# UNITED STATES PATENT AND TRADEMARK OFFICE

APPLICATION NO.	FILING DATE	FIRST NAMED INVENTOR	ATTORNEY DOCKET NO.	CONFIRMATION NO.
10/705,871	11/13/2003	William George Carberg	839-1367	6296

# Office Action Summary

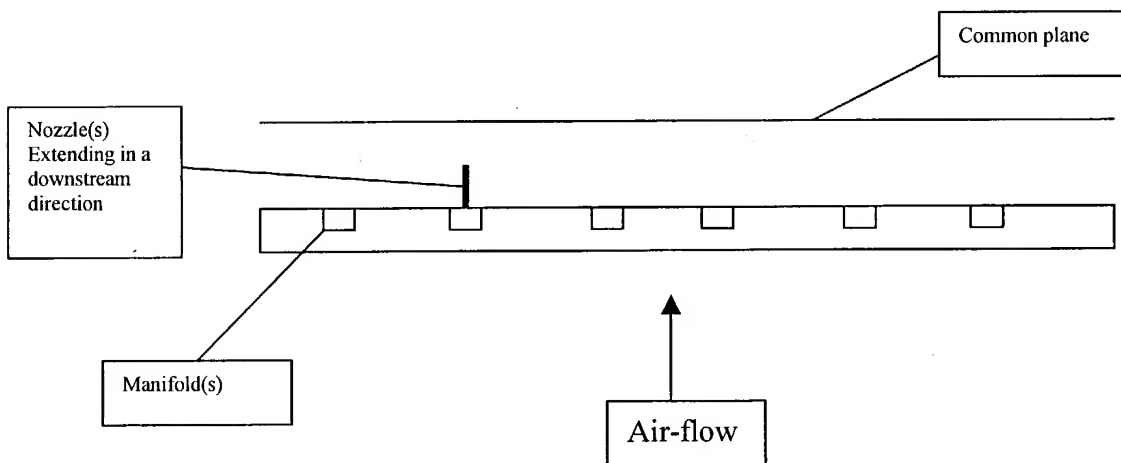
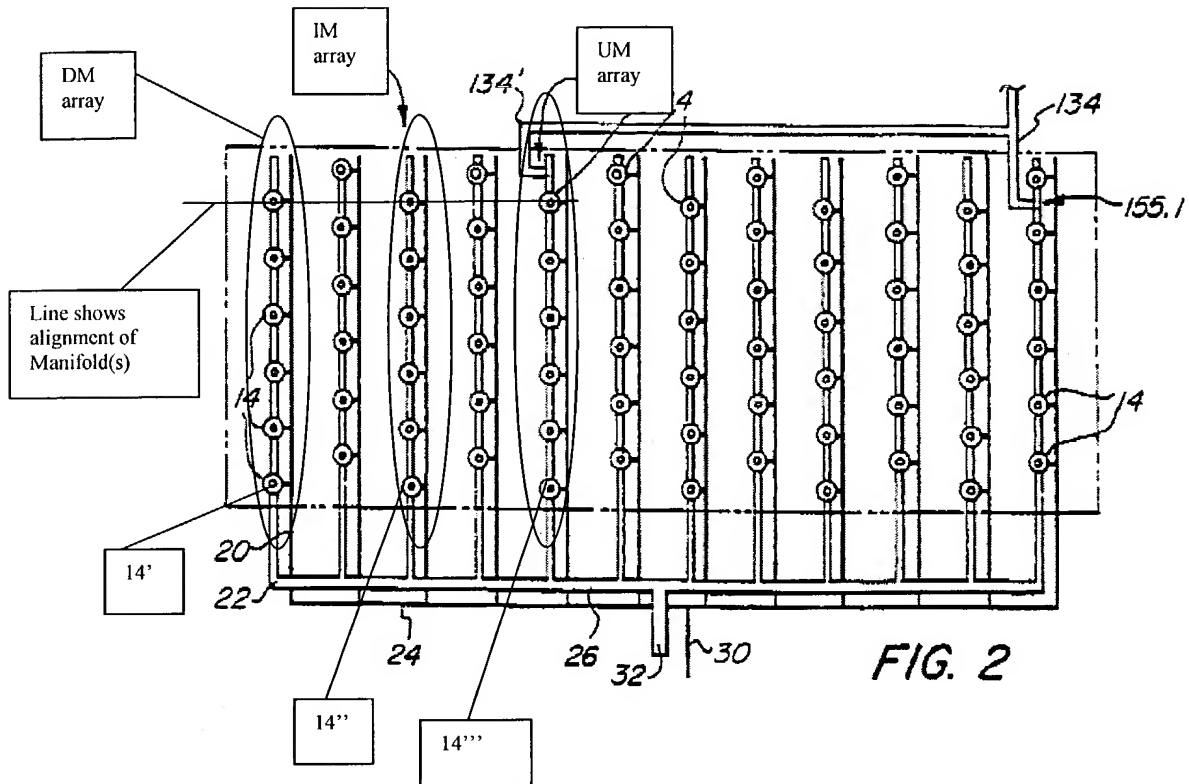
With respect to claim 1, **Early** teaches a water mister apparatus for supplying humidified air to a compressor forming part of a gas turbine, comprising: an air inlet duct for supplying air to the compressor; a plurality of manifolds arranged in the air inlet duct for communication with a supply water and extending between opposite walls (W1, W2) of the duct, in spaced arrays (DM; IM, UM) thereof in a direction of air flow through the duct to the compressor, manifolds of each array thereof lying in substantial alignment with manifolds of other arrays thereof in the direction flow through the duct to the compressor; a plurality of nozzles (14'; 14''; 14''') in communication with each of the manifolds; a first set said plurality of nozzles 14' extending downstream direction from a downstream array of manifolds DM; a second set of said plurality of nozzles 14'' extending in a downstream direction from manifolds of said plurality thereof arrayed intermediate IM an array of upstream UM manifolds of said plurality thereof and said downstream DM array of manifolds; a third set said plurality nozzles 14''' extending in a downstream direction from said upstream UM array manifolds; said first 14', second 14'' and third 14''' sets of nozzles of said downstream DM, intermediate IM and upstream UM arrays of manifolds, respectively, terminating substantially in a common plane extending across said duct and generally normal to the direction of air flow through the duct. See particularly **Figures 1, 2** above; and column 1 lines 35-39 of **Early**.

With respect to claim 4, **Early** teaches that the nozzles of the first 14', second 14'' and third 14''' sets thereof are arranged in groups of three nozzles each with the three nozzles of each group being carried by aligned manifolds of the respective arrays thereof, the groups of nozzles being spaced across the duct from one another. See particularly **Figures 1, 2** above.

With respect to claim 6, **Early** teaches a water mister apparatus for supplying humidified air to a compressor forming part a gas turbine, comprising: an air inlet duct for supplying to the compressor; a plurality of manifolds (DM; IM, UM) arranged in the air inlet duct for communication with a mister supply and extending between opposite walls (W1, W2) of the duct in downstream, intermediate and upstream arrays thereof spaced from one another in a direction of air flow through the duct to the compressor, each array having a plurality of said manifolds spaced one from the other and lying generally in a common plane generally perpendicular the direction air flow, manifolds of each array thereof lying in substantial alignment with the manifolds of other arrays thereof in the direction of air flow; a plurality of nozzles (14'; 14''; 14''') in communication with each of the manifolds; a first set said plurality of nozzles 14' extending in a downstream direction from said downstream array of manifolds; a second set of said plurality of nozzles 14'' extending in a downstream direction from said intermediate array of manifolds; a third set of said plurality of nozzles 14''' extending a downstream direction from said upstream array of manifolds; said first, second and third sets of nozzles of said downstream, intermediate and upstream arrays manifolds, respectively, terminating substantially a common plane extending across the duct and generally normal to the direction of air flow through the duct. See particularly **Figures 1, 2** above; and column 1 lines 35-39 of **Early**.

With respect to claim 9, **Early** teaches that the nozzles of the first 14', second 14'' and third 14''' sets thereof are arranged in groups of three nozzles each with the three nozzles of each group being carried by aligned manifolds of the respective arrays thereof, the groups of nozzles being spaced across the duct from one another. See particularly **Figures 1, 2** above.
